# Rezoning Transportation Analysis

Petition Number: 2022-151

Date	Description
1-25-23	First Review (TM)

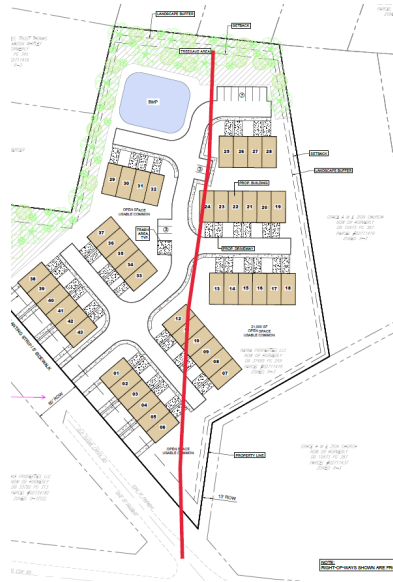
### 2. Traffic Study:

A Traffic Impact Study (TIS) is not required for the complete review of this petition due to the site generating less than 2,500 daily trips and/or not triggering any other City TIS requirements.
